Access Compliance Report Public Rights-of-Way (Curb Ramps)

Main Street: CHAPMAN_AVE		Cross Street: RANCHO_SANTIAGO_BLVD		Location:	NW
ADA ID: RPRK211223125852	Ramp Type: Type 4 - Parallel	Initial Pass/Fail: Pass	Overall Compliance: No	Severity Score:	2
Codes/Mitigation Info/Possible Solution			Field Measurements/Component Compliance

Obstruction and Utility Measurement/Component Compliance

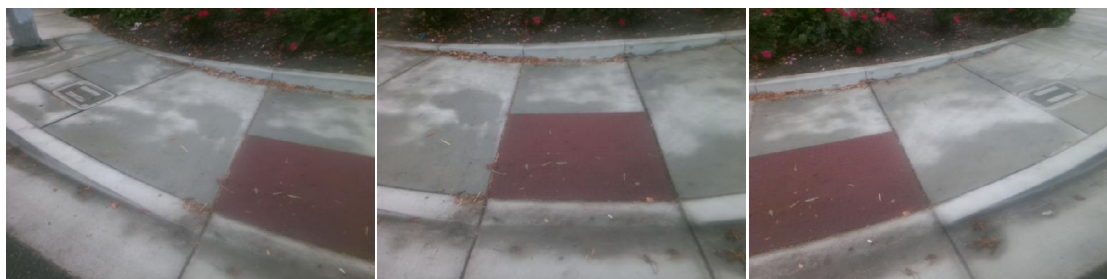
Remove & Replace Curb Ramp With Two New Directional Ramps or Equivalent. Utility Present.

R304.5.3, R304.2.2-Perp, R304.3.2-Para, STD 1115
